Article No.:	4010 0270	
Description:	Alteration of HP 336 to full capacity	
Date / Page:	12th September 2007 / 1 of 1

## Alteration of HP 336 to full ink capacity

## New product for ink cartridge HP336

1a) Cross-section of HP 336 with separating wall.

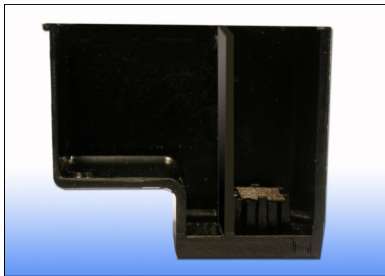
The ink cartridge HP 336 has a separating wall within the ink chamber (see Fig. 1a). After removing this separating wall by either cutting or breaking them out the full cartridge capacity can be utilised (see Fig. 1b). The ink supply of the HP 336 to the preceding nozzle chamber (filter area) is lower than for example with the HP 338 ink cartridge. This difference in height is bridged by a custom formed sponge (see Fig. 1c). Using this sponge the chamber will be completely filled. Samples are available on request.
